**Glaser-Dirks Flugzeugbau GmbH**  
Im Schollengarten 19-20, 7520 Bruchsal 4  
Telefon 07257-1071 Telex 7822410 GLDG  
LBA anerkannter Herstellungsbetrieb IB 25  
LBA anerkannter Luftfahrttechnischer Betrieb IIA 279.

Technical Note

No 301/12

Subject: Emergency release mechanism of the one piece canopy

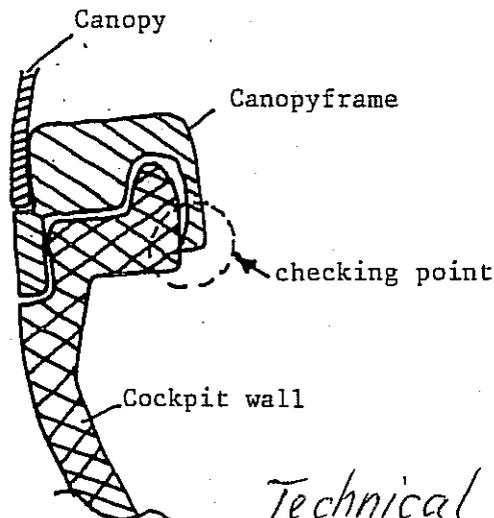
B 1) Inspect the welds of the stopping sheet at the fuselage side - canopy fitting (look at the scetch).

If they are projekting, You have to file them flat. (Protect the filed area with a rust protection paint afterwards. )

enlarged

wrong

right

File the weld flat

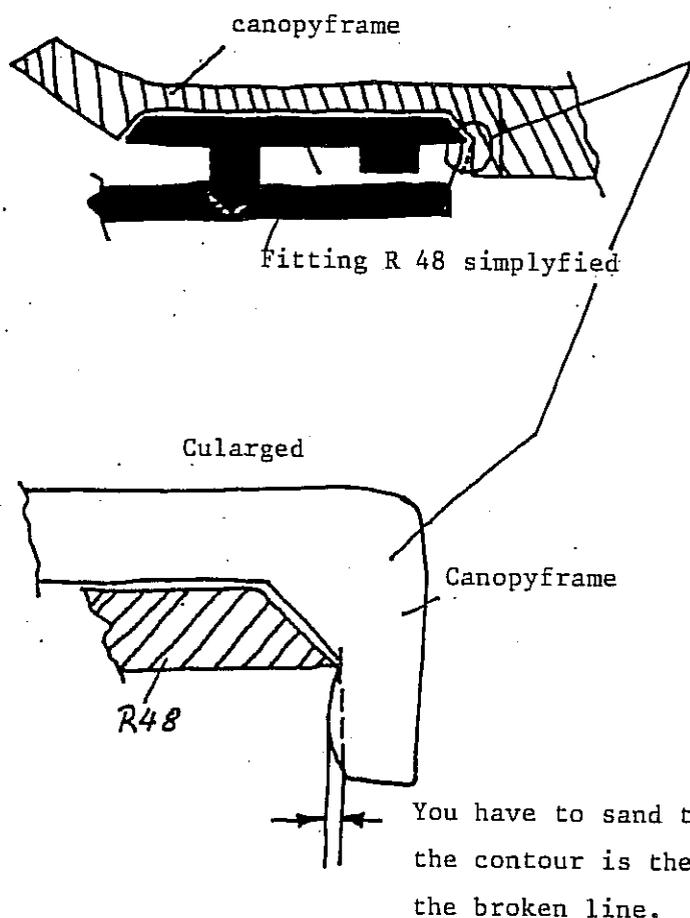
B 2) If this work was unsuccessful, You have to check, wether the canopyframe undercuts at the inner bead in the front sector. (look at the scetch)

If there are undercuts, (You can see it exactly at the rubpoints at the canopyframe and the cockpitwall) You have to eliminate them by sanding with an abrasive paper (60 Grit).
